**In the Drawings:**

**REMARKS**

Isaac Dyck  
Originally Filed Sheet 1 of 5  
Battison - 85291-102 ADB

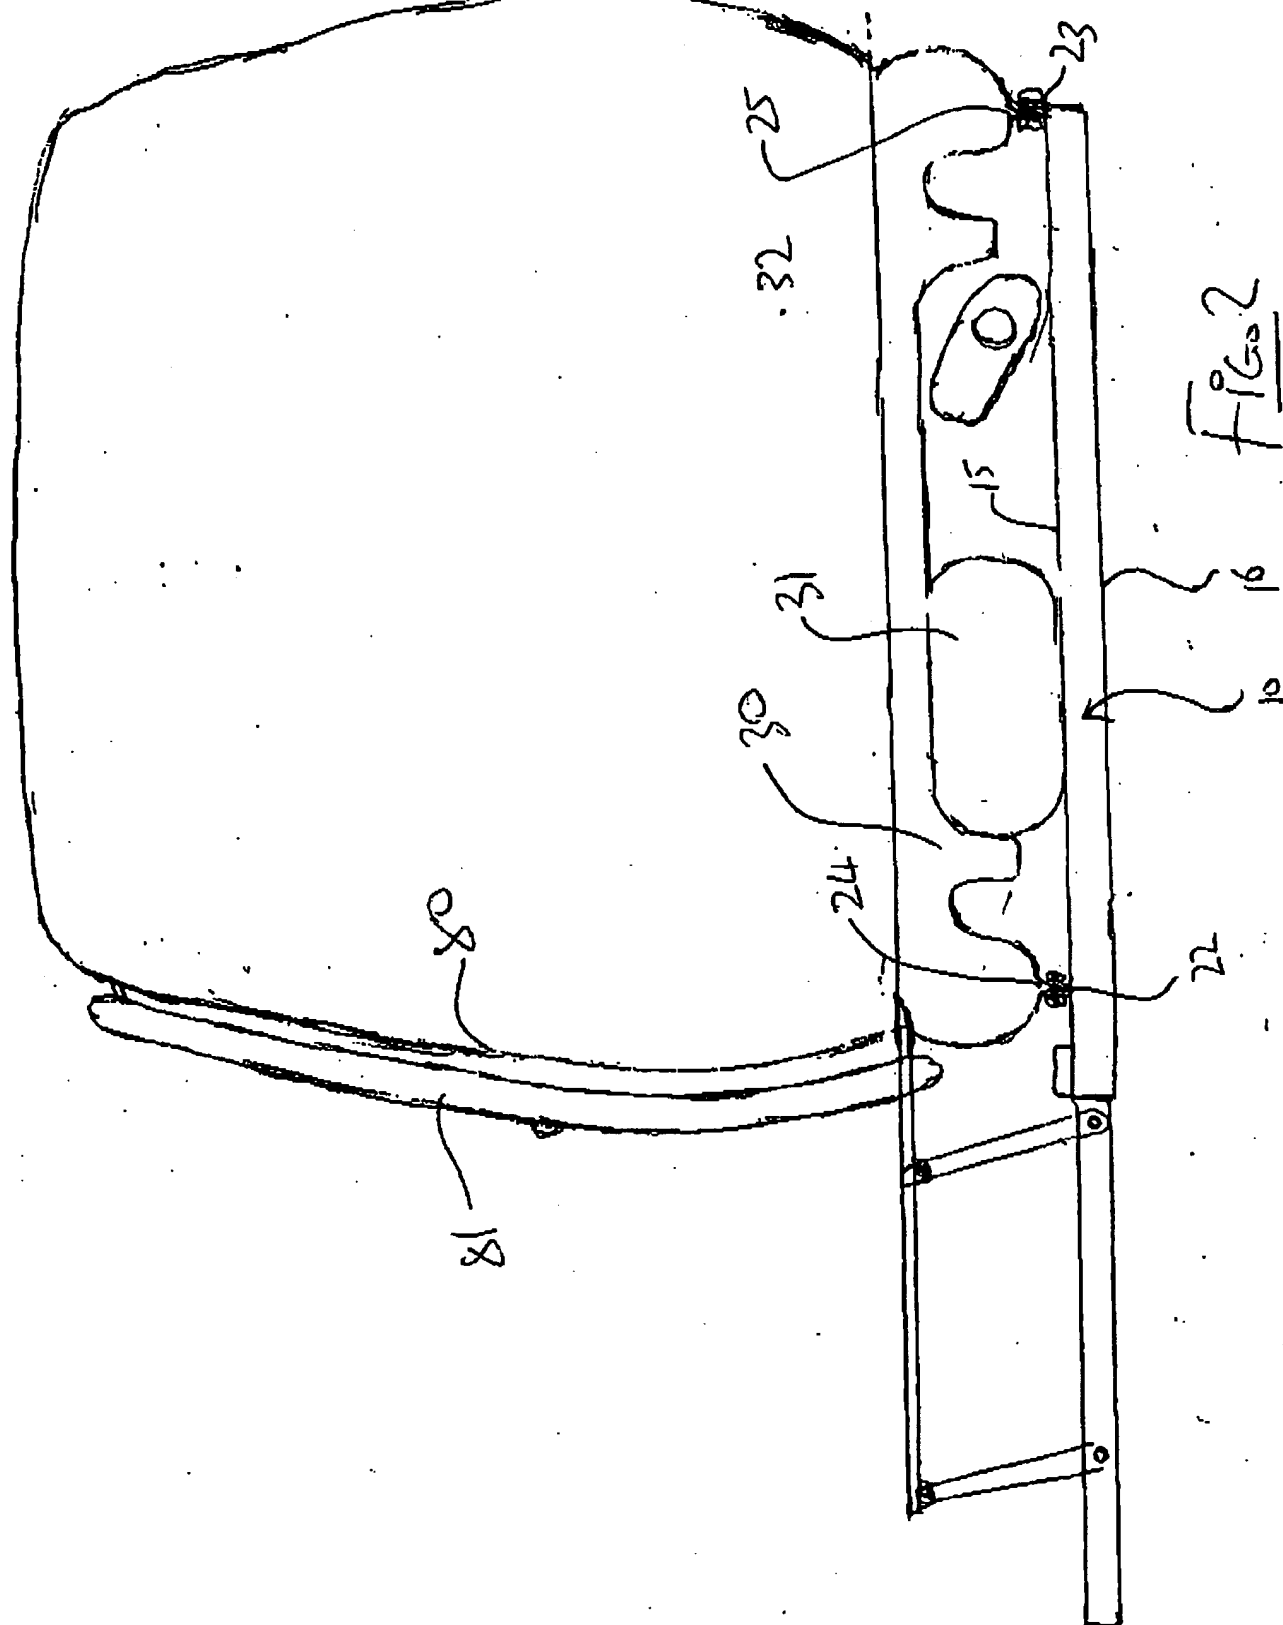
Figures 1 to 5 have been amended to remove copy machine marks, improve the character of lines and numbers, improve the legibility of reference characters and improve the quality of figure legends

Isaac Dyck  
Originally Filed Sheet 2 of 5  
Battison.- 85291-102 ADB

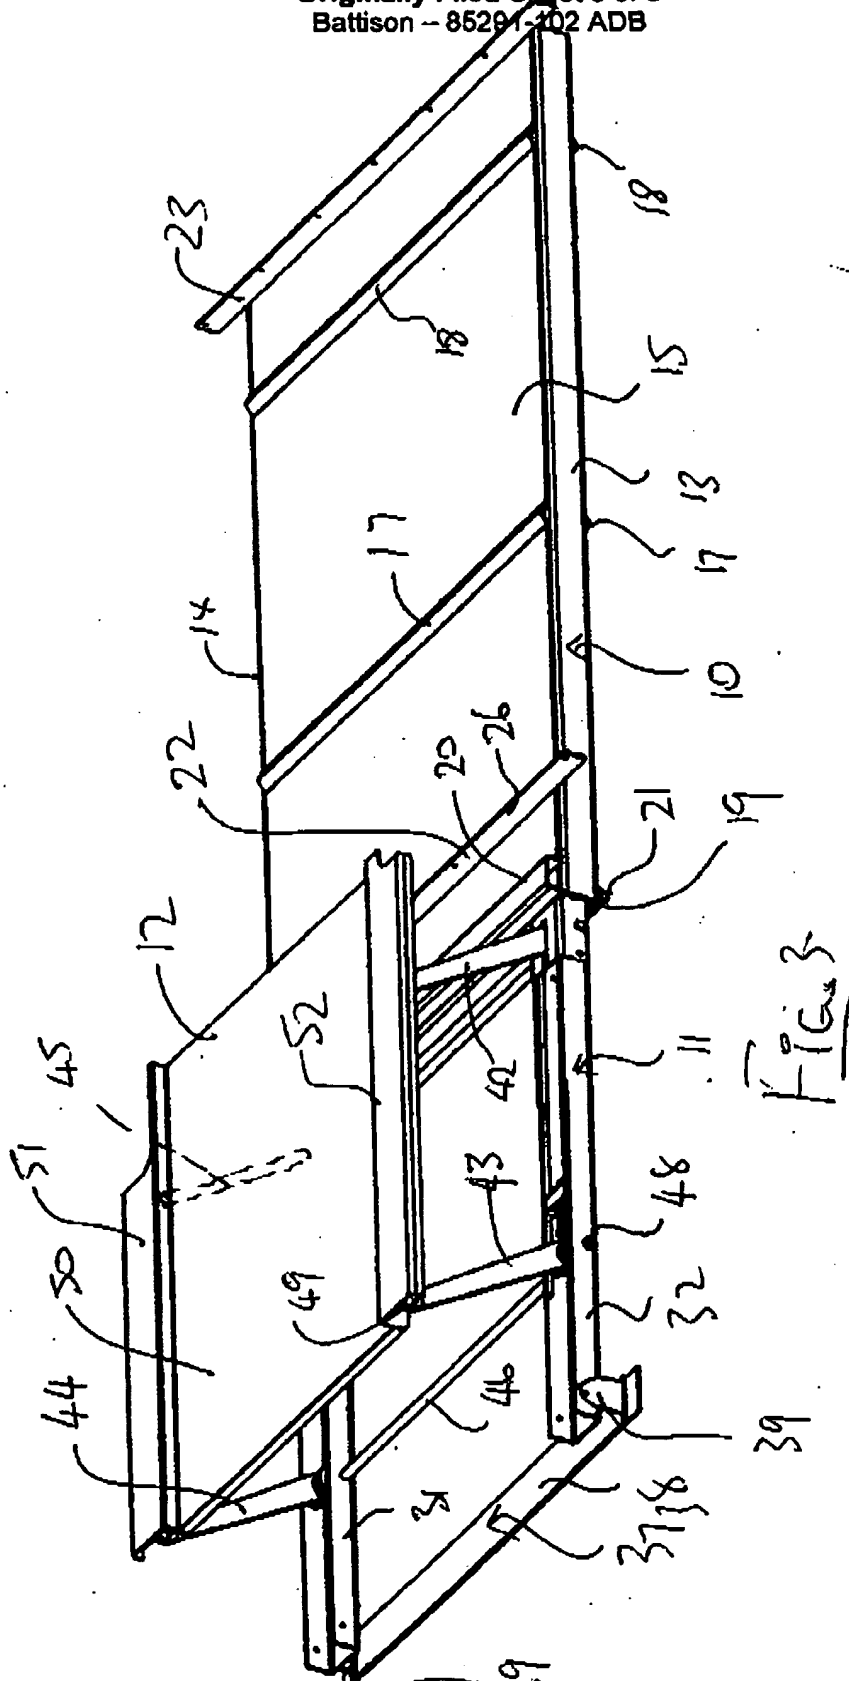
Figures 2 to 5 have been further amended to correct the margins.

Figure 2 has been further amended to change the reference characters indicating the gas tank and muffler in order to correspond to an amendment to the specification.
